FINAL SAFETY ANALYSIS REPORT REVISIONS
HOPE CREEK GENERATING STATION
DOCKET NO. 50-354

Public Service Electric and Gas Company (PSE&G) hereby submits various revisions to the Hope Creek Generating Station (HCGS) Final Safety Analysis Report (FSAR). The attached revisions to the HCGS FSAR contain: 1) revisions to maintain FSAR consistency with the Technical Specifications; 2) revisions to reconcile as-built plant discrepancies; and 3) general changes to the FSAR text, tables and figures.

Attachment 1 provides a brief summary and explanation for each change while Attachment 2 contains the actual marked-up sections of the FSAR. These revisions will be incorporated in FSAR Amendment 15 after fuel load but are being filed now in order to accurately reflect the design and operation of HCGS and support the issuance of an operating license. In addition, an affidavit is provided to affirm that the matters set forth in this transmittal are true and accurate.

FIGURE 8.2-2

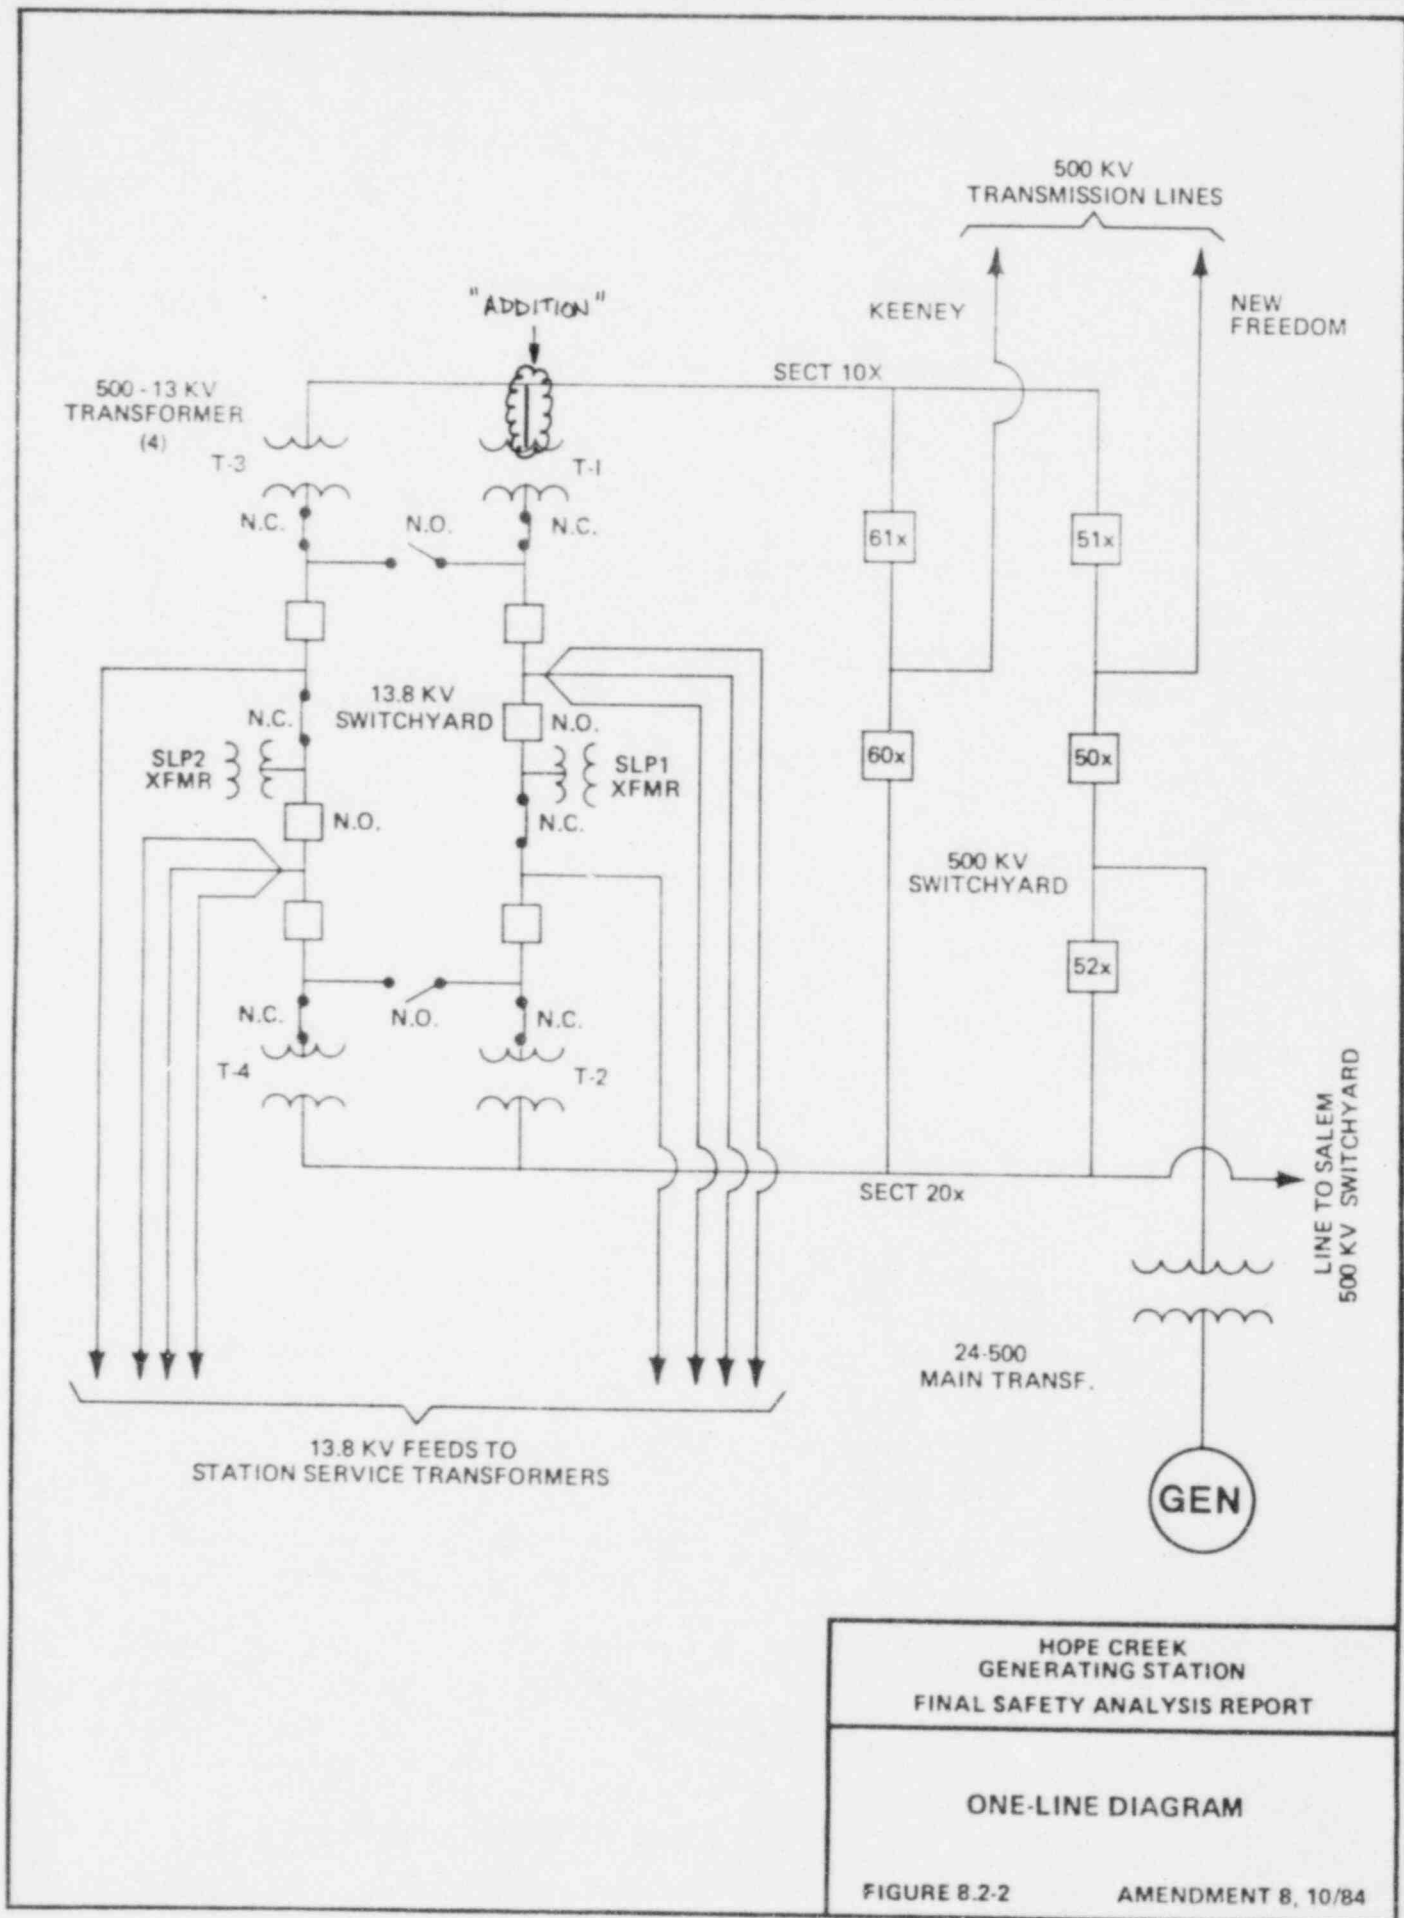
- 8.1.1 Revisions describe the addition of
8.2.1.4 the island substation and 13-kV feeders
8.2.1.5 to the substation.
F8.2-2
8.3.1.1.1
8.3.1.1.2.10
F8.3-1,2
- T8.3-1 Revisions reflect as-tested plant conditions.
pg. 2,4,10/10

ISLAND SUBSTATION TRANSFORMERS SLP3 AND SLP4 ARE TAPPED FROM 13.8-KV BUS SECTIONS S4 AND S9 RESPECTIVELY, AND PROVIDE SERVICE FOR 13.8-KV ISLAND POWER DISTRIBUTION SYSTEM VIA 13.8-KV SWITCHGEAR LOCATED IN THE HCGS SWITCHYARD.

FIGURE 8.3-16
SHEET 7 OF 8

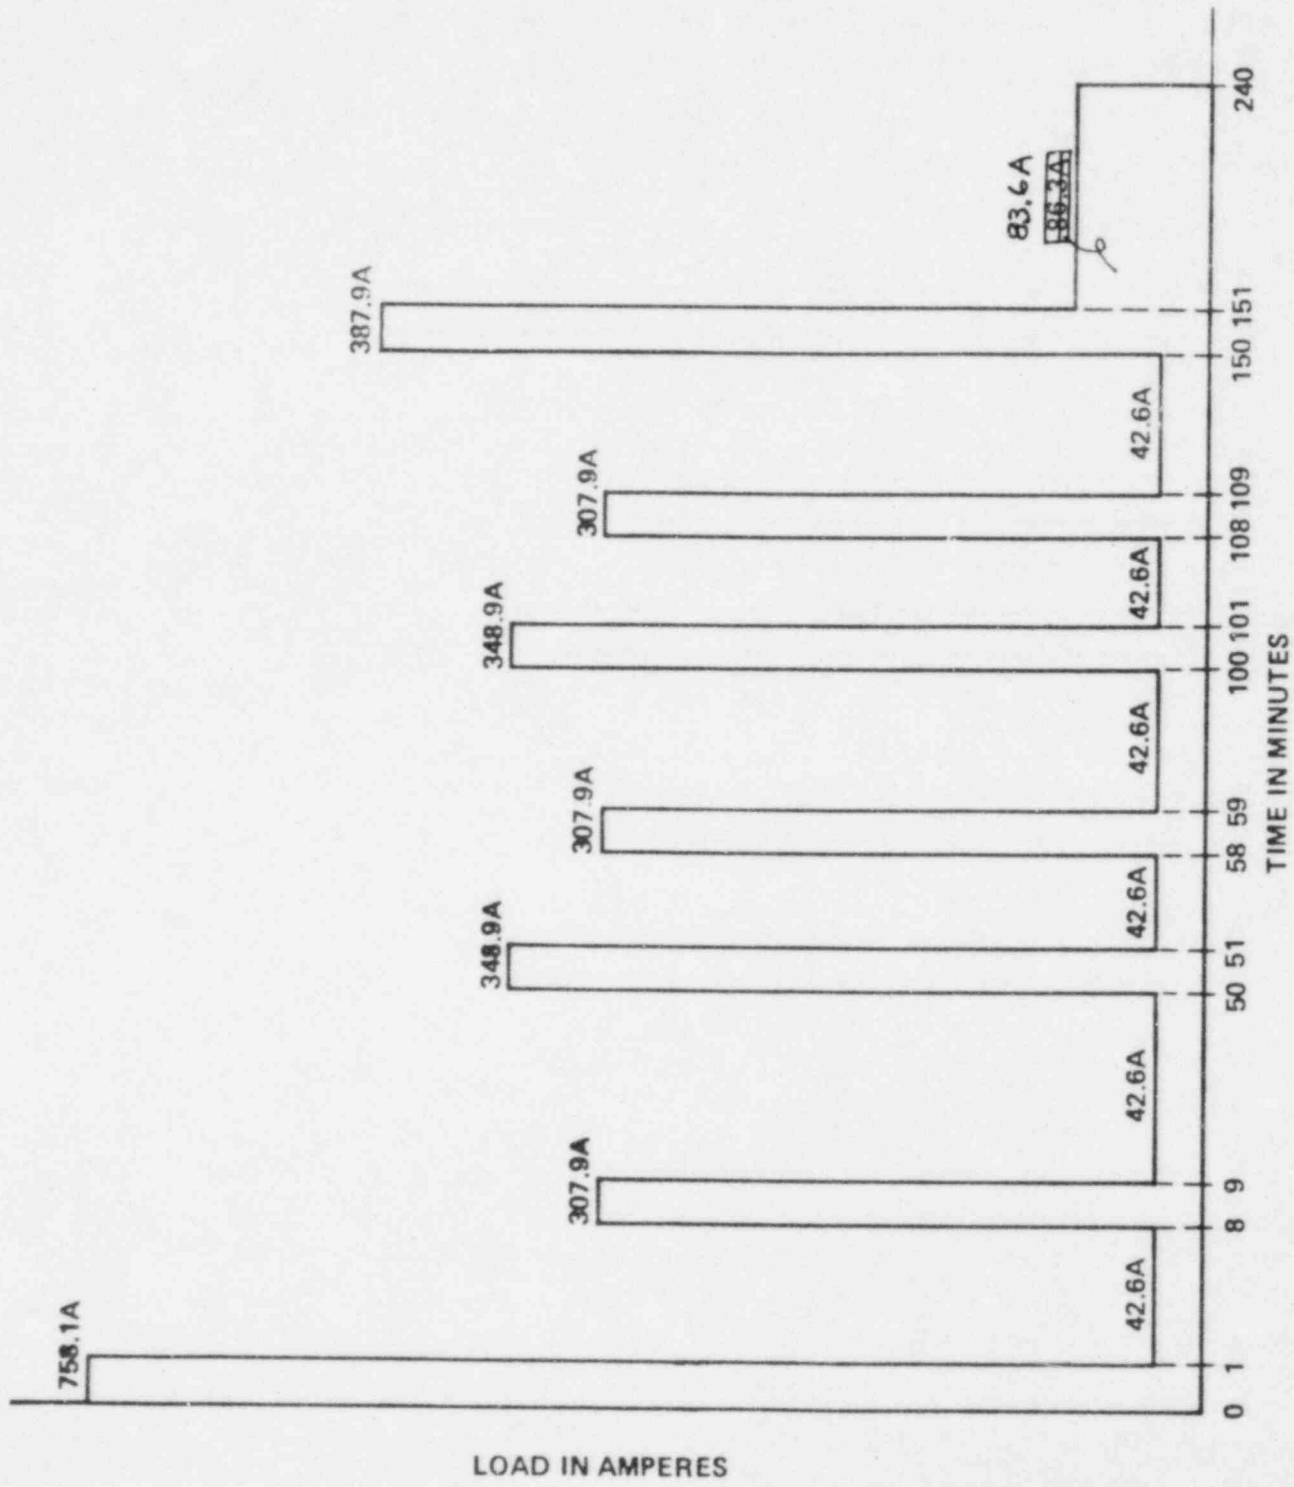
(16) TIME INDICATED IS SEQUENCE TIME REQUIRED IF CHILLERS ARE OFF PRIOR TO DBA OR LOP.
IF CHILLERS ARE ON PRIOR TO DBA OR LOP, SEQUENCE TIME REQUIRED IS 160 SECONDS.
